EASTERN REGIONAL POWER COMMITTEE

MINUTES OF 26th PROTECTION SUB-COMMITTEE MEETING HELD AT ERPC, KOLKATA ON 22.12.2014 (MONDAY) AT 11:00 HOURS

ITEM NO. B.1: Disturbance in FSTPP, NTPC and JSEB system on 06.11.2014

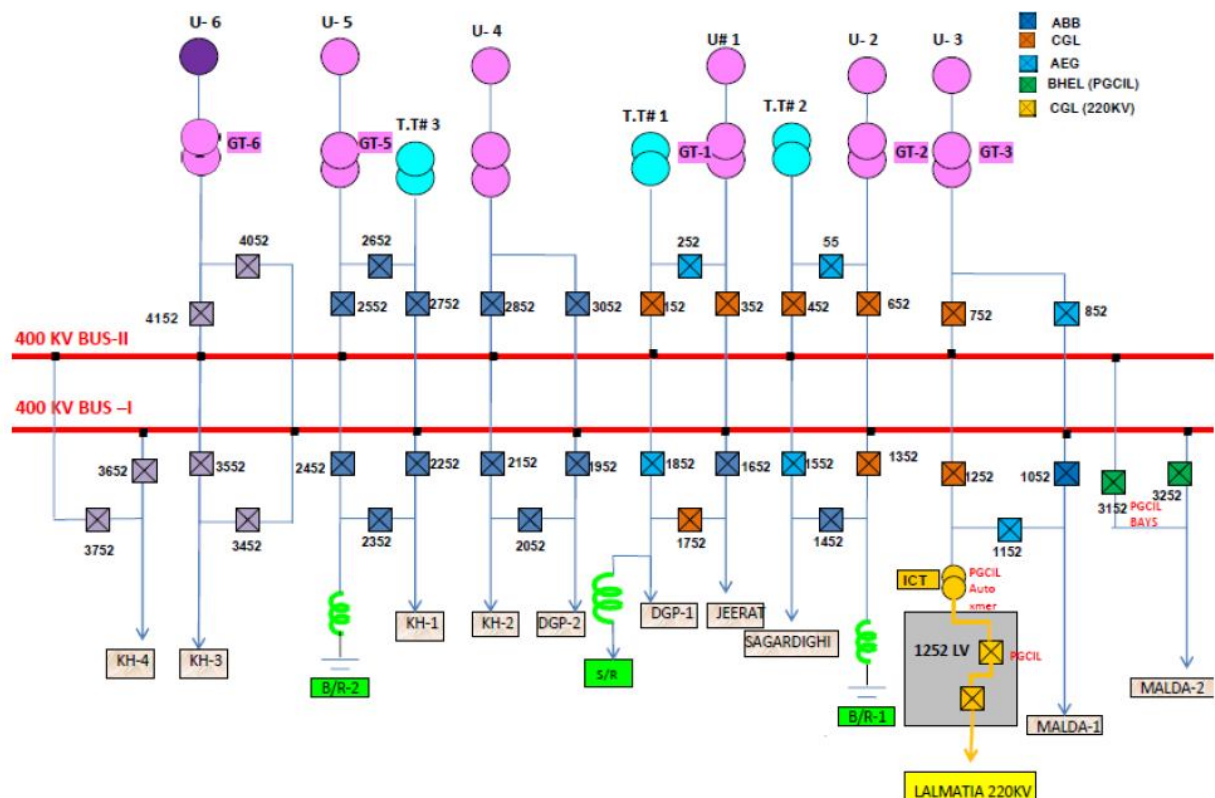
It appears that sequence of events were initiated due to malfunctioning of BFR element for the main breaker of 400kV Farakka-Kahalgaon-II at Farakka which was under shutdown and connected to Bus-II at Farakka S/s. Due to actuation of BFR, all the main breakers connected to 400kV Bus-II at Farakka S/s tripped. As the tie breaker of 400/220kV ICT and 400kV Farakka-Malda-I had already been kept out of service prior to the tripping due to breaker replacement work,

the 400/220kV ICT connected to Bus-II also tripped. With the tripping of above ICT the entire loads comprising of Lalmatia, Dumka became radial on Kahalgaon (NTPC) and consequently 132kV Kahalgaon (NTPC)-Lalmatia tripped on O/C leading to total power failure at Lalmatia with the 220kV bus becoming dead.

In the absence of main CB, 400kV FSTPS-Malda-II which was connected to Main Bus-II through tie CB also tripped and in order. However, tripping of 400kV Farakka-Kahalgaon-III from Kahalgaon end on receipt of DT from FSTPP end needs to be explained.

- Mal operation of BFR at FSTPP end needs to be investigated.
- DT reception at Kahalgaon end for 400kV Farakka-Kahalgaon-III line needs to be explained.
- It is to be noted that 400kV FSTPS-Malda-II is a vital link between ER-NR and ER-NER when low hydro situation prevails in winter season and prolonged outage of Main CB of the said ckt is a serious concern for the safety and security of the Grid. Hence ER-II requested to expedite the commissioning work of main CB at Farakka.
- NTPC Farakka is advised to expedite the commissioning of remaining un-commissioned breakers at FSTPP for a stronger coupling of 400kV Bus-I & II.

NTPC informed that 400kV FSTPP-KhSTPS-II, main CB BFR element timer had activated and tripped all the main breakers connected to 400kV Bus-II at Farakka S/s.

NTPC explained with presentation that on inspection the BFR element was found short which activated the timer circuit. Thereafter, the contact has been replaced with new one and they are planning to replace the existing BFR with numerical relay. Presentation is enclosed at **Annexure-B1**.

Regarding tripping of 400kV Farakka-Kahalgaon-III from Kahalgaon end, NTPC Kahalgaon informed that they received DT from Farakka end and also confirmed from PLCC counter reading.

PCC advised NTPC Farakka to check the PLCC counter and find out the reason for sending DT.

PCC also advised to expedite the commissioning of remaining un-commissioned breakers at FSTPP for a stronger coupling of 400kV Bus-I & II and update the status in next PCC meeting.

MERAMUNDALI S/S 14.09.2014 AT 18:55 Hrs

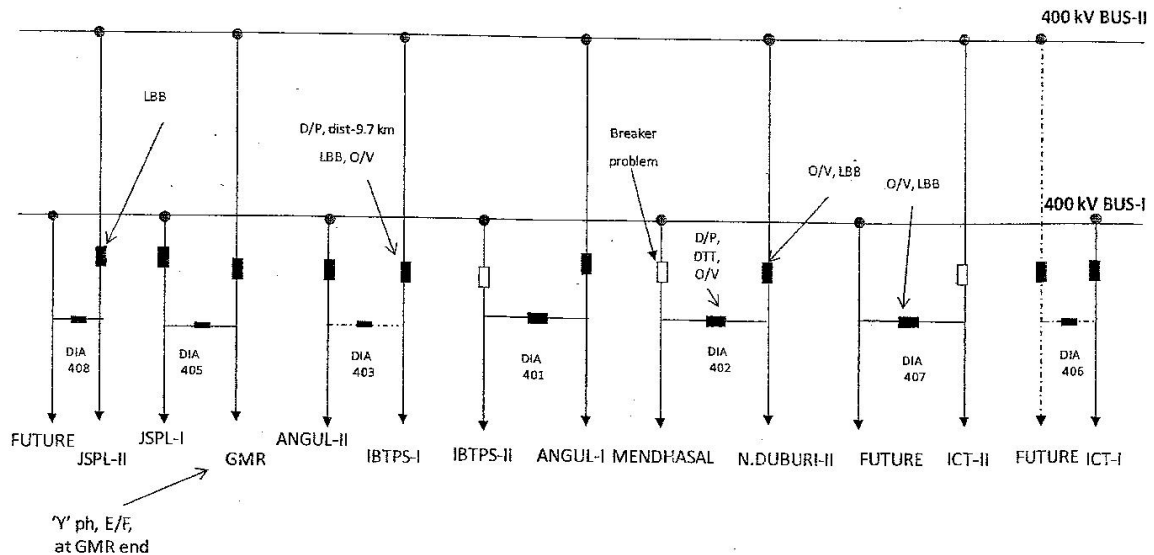
It appears that, there were two separate events occurring at 18:41hrs and at 18:55hrs. At 18:41hrs 400kV Angul-TSTPP tripped from Angul end on R-N fault. At TSTPP end Auto reclosure operated successfully indicating that the fault was transient in nature, but at Angul end Auto reclosure got blocked which needs to be investigated.

Subsequently, at 18:55hrs, 400kV Meeramundali-IBTPS-I (idle charged from Meramundali end) tripped on Y-N fault. However as reported by OPTCL, due to suspected delayed tripping of 400kV Meeramundali-IBTPS-I from Meeramundali end, LBB got actuated at Meramundali end. Hence, all the elements connected to 400kV Bus-II of Meramundali tripped. However, the breaker connected to Bus-II of 400kV Meramundali-GMR at Meramundali end tripped from remote end only which needs to be investigated. Also, presently the main CB of 400kV Meeramundali-Mendhasal was not in service and said line was charged through the tie CB of 400 kV Meeramundali-Duburi Ckt-II which was connected to Main Bus-II. Hence, though the line tripped on operation of LBB, the tie breaker observed the fault and tripped on DP. Thus, tripping of 400 kV Meeramundali-Duburi Ckt-II (idle charged from Meramundali end) on LBB, led to outage of 400kV Meeramundali-Mendhasal also. Relays at Angul end of 400kV Anugul-Meramundali-I had also picked up detecting Y-N fault beyond Z-3 due to delayed opening of breaker of 400kV Meramundali-IBTPS-I at Meeramundali end but the relays did not trip. This is suspected to be a maloperation at Anugul end. Hence, finally the fault was cleared from Bolangir end with DT was sent to Angul. It is suspected that JSPL units might have tripped due to the above incident. Hence, now, only two lines and one ICT viz. 400 kV Meeramundali-JSPL Ckt-I, 400 kV Meeramundali-Angul Ckt-II and 400/220kV ICT-I remained connected with Bus-I at Meeramundali. It is suspected that ICT-I had also tripped and with JSPL-Meramundali-I tripping, there was no source/evacuation path from Meramundali Bus-I and 400kV Anugul-Meramundali-II went under floating condition. Subsequently, the line tripped on receipt of DT at 19:05Hrs from Meramundali end on suspected hand tripping of the idle line from Meramundali end.

- The fault persistence time of 280ms is a violation of CEA (Grid Standards) Regulations, 2010. As per Cl.3 (e) regarding 'Standards for Operation and Maintenance of Transmission Lines', the maximum fault clearance time for 400kV Transmission system is 100ms.

- Failure in tripping of 400kV Meeramundali-GMR from Meramundali end on operation of LBB (though other lines connected to Bus-II tripped) needs to be checked. The line tripped from GMR end only even after LBB actuation and the same needs to be investigated.

- Failure in tripping of 400kV Meramundali-Anugul-I from Meramundali end on operation of LBB(though other lines connected to Bus-II tripped) needs to be checked. Also failure in clearing the fault from Anugul end also needs to be investigated (relays at Anugul end had only picked up).

- OPTCL is requested to expedite commissioning of the pending main/tie breakers presently not in service at Meramundali to enable stronger coupling of Bus-I & II at Meramundali.

- Blocking of Auto reclose at Angul end though the same was successful at TSTPP end needs to be investigated.
- Tripping of 400/220kV ICT-I and 400kV JSPL-Meramundali-I needs to be confirmed and corroborated.

In 24th PCC, OPTCL informed that due to some problem in trip circuit there was delayed clearance of fault in the idle charged 400kV Meramundali-IBTPS-I line which activated the LBB at Meramundali S/s and all the elements connected to Bus-II tripped.

PCC advised OPTCL to review the zone settings time to time for under construction lines which were idle charged and the entire line should be covered in zone-1.

PCC advised OPTCL to submit the complete plan of CB replacing and bus-bar protection installation at Meramundali S/s. OPTCL agreed.

It was informed that R-N fault was observed at Angul end. OPTCL updated the status as follows,

- The zone 2 setting of Distance relays for under construction lines was made zero.*
- The 400kV CB for BUS –II of 407 diameter (ICT-II) was commissioned on 30.11.2014*
- The 400kV CB for BUS –I of 402 diameter (Mendhasal) installation completed expected to be commissioned by 4th week of December, 2014.*
- The 403 Dia tie CB overhauling would be completed by 30.11.2014.*
- The installation of BUS-I CB of 401 diameter (Ib-II) is in progress and expected to be commissioned by 15th January'2015.*
- 220kV Bus bar protection for Meramundali Grid is in progress, expected to be completed by 31st December'2014.*

Fault Report: 08.11.2014: 23:20 Hrs

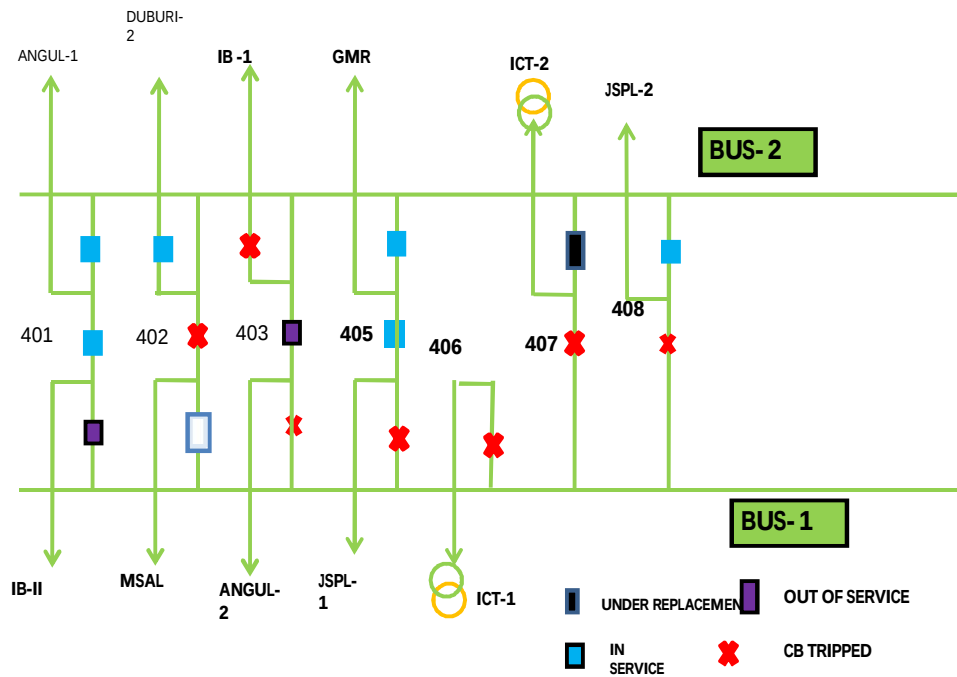
- LBB operation for 400kV Bus-I when LBB should operate for 400kV Bus-II is a serious anomaly and needs to be investigated.
- Also, as the PMU has detected fault clearance time of 80ms, LBB operation timer at Meramundali needs to be corrected for delay as per standards.

- LBB operation of tie CB of 400kV Meeramundali-Mendhasal (as main CB is dismantled) is not in order. Also, non-opening of main CB of Anugul-Meramundali-I connected to Bus-II could not be explained. Hence, selection of breakers for LBB needs to be audited/verified as no logic w.r.t the tripping could be detected and it is possible that wiring/selection of breakers for LBB operation were not in order.

- Page | 4
- PMU plots depict initially a R-B phase fault and subsequently a B-Phase fault after 1sec which needs to be explained.
- In the last PCC meeting, it was decided to review the protection settings of the lines being kept idle charged from Meramundali end and modify them to ensure instantaneous tripping irrespective of the zone of the fault. OPTCL may furnish the status i.r.o above.

- OPTCL is advised to expedite the commissioning of remaining un-commissioned breakers at Meramundali for a stronger coupling of 400kV Bus-I & II.

OPTCL explained that fault was in Meramundali-IbTPS line-I and the CB at Meramundali has cleared the fault in 80msec. However, the fault was extended to Bus-I via Dia 408 and 405 and the busbar protection had tripped all the lines connected to Bus-1.

OPTCL informed that they are suspecting defect in one of the CTs of the bus bar protection.

PCC advised to check the healthiness of CT and enable CT supervision for all CTs. OPTCL agreed.

**ANALYSIS OF SYSTEM DISTURBANCE ON
29.11.14 AT MENDHASAL GRID**

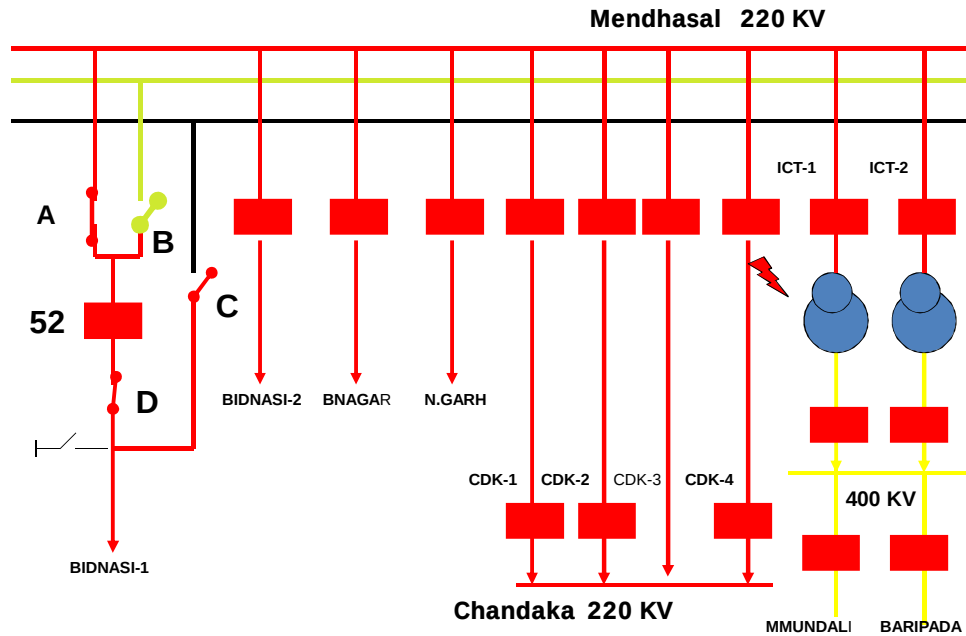
Various 220kV and 400kV lines tripped due to blasting of Y-Ø LA of 220kV Mendhasal-Chandaka-IV at Mendhasal.

OPTCL explained the tripping incidence with a presentation given at **Annexure-B2.2**. There was fault in Y-ph LA of 220kV Mendhasal-Chandaka -4 at Mendhasal S/s and the Distance Protection has cleared the fault in Zone 1 at Mendhasal end. Fault being on Zone2 from Chandaka end, Distance Relay had tripped on Zone 2 with time delay of 487 mSec. Because of delay in clearance of fault at Chandaka end of line-4, the O/C E/F protection of Mendhasal-Chandaka line-1, 2 and 3 were tripped from Mendhasal end.

It resulted in outage of approx 190 MW load causes OV actuation of 400 KV Mendhasal-Meramundali line and tripped after 4998 mSec. (Concluded from testing, The relay picks up 70.04 V, drops out at 66.52 V). On the day of disturbance, the relay had been picked up at 82.2 Volt and remained with voltage of 68.2V till the elapse of setting value.

On enquiry of the relay settings at Chandaka S/s, OPTCL informed that they have changed the zone 2 timing of distance protection to 0.3 s and time setting of OC/EF at Mendhasal have been changed from 0.1 to 0.25 dial (More than Z2 setting of 300mSec.) after the incident. The OV setting on 400Kv Mendhasal-Meramundali line at Mendhasal end had been changed from 70V to 72 V(Relay tested and found with drop out of 95% of nominal).

PCC advised OPTCL to install the PLCC system to enable inter tripping. OPTCL agreed.
